APPLICATION NO.	FILING DATE	FIRST NAMED INVENTOR	ATTORNEY DOCKET NO.	CONFIRMATION NO.
10/564,341	01/24/2006	Michael Vogel	1016710010P	7825
34284	7590	11/12/2009	EXAMINER	
Rutan & Tucker, LLP. 611 ANTON BLVD SUITE 1400 COSTA MESA, CA 92626			HORNBERGER, JENNIFER LEA	
		ART UNIT	PAPER NUMBER	
		3734		
		MAIL DATE		DELIVERY MODE
		11/12/2009		PAPER

<b>Office Action Summary</b>	<b>Application No.</b> 10/564,341	<b>Applicant(s)</b> VOGEL ET AL.
	<b>Examiner</b> JENNIFER L. HORNBERGER	<b>Art Unit</b> 3734

**DETAILED ACTION**

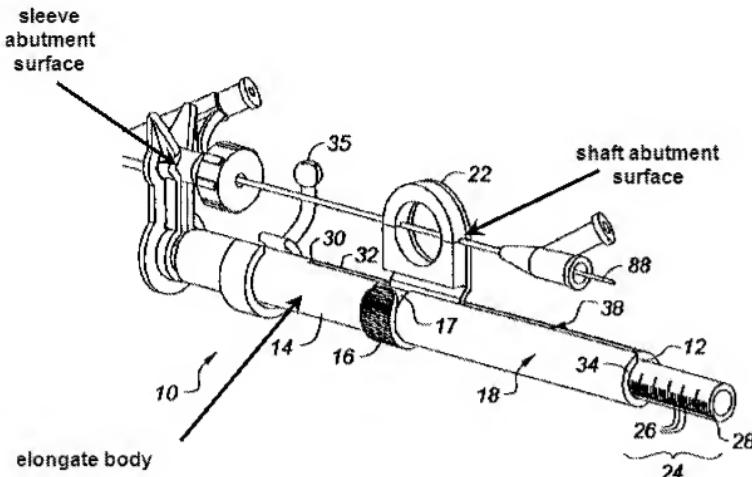
Regarding claim 1, Korotko et al. disclose a device capable of being used as a safety clip for a medical catheter that comprises a shaft and a sleeve, the device comprising: an

elongate body (14) having a first end, a second end and an intermediate portion; an attachment member (35); and a sleeve abutment surface (see figure below) at the first end of the body and a shaft abutment surface (see figure below) at the second end of the body spaced from the first end of the body, one of the sleeve abutment surface and shaft abutment surface defining a sliding member (22) configured for stepless adjustment of the distance separating said sleeve abutment surface and said shaft abutment surface (col. 5, ln. 22-25).

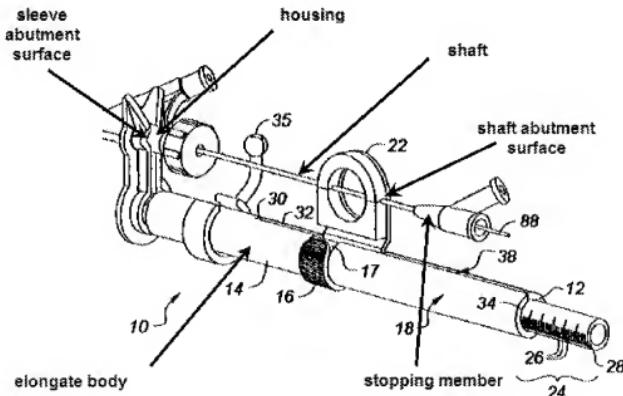
Regarding claim 16, Korotko et al. disclose a second spacing member (11) coupled to the second end of the elongate body (Fig. 1, 5)

Regarding claims 11, 22, and 23, Korotko et al. disclose a safety clip for a medical catheter, comprising: an elongate body (14) having a first end and a second end spaced from the first end; an attachment member (11) coupled to the elongate body; and a first spacing member (22) coupled to the first end of the elongate body, at least one of the first spacing member and elongate body configured to permit movement of the first spacing member relative to the second end of the elongate body (col. 5, ln. 22-25), the engagement member includes a plurality of sets of jaws, each of the sets of jaws configured to grip a different diameter member of a medical catheter (col. 5, ln. 26-41).
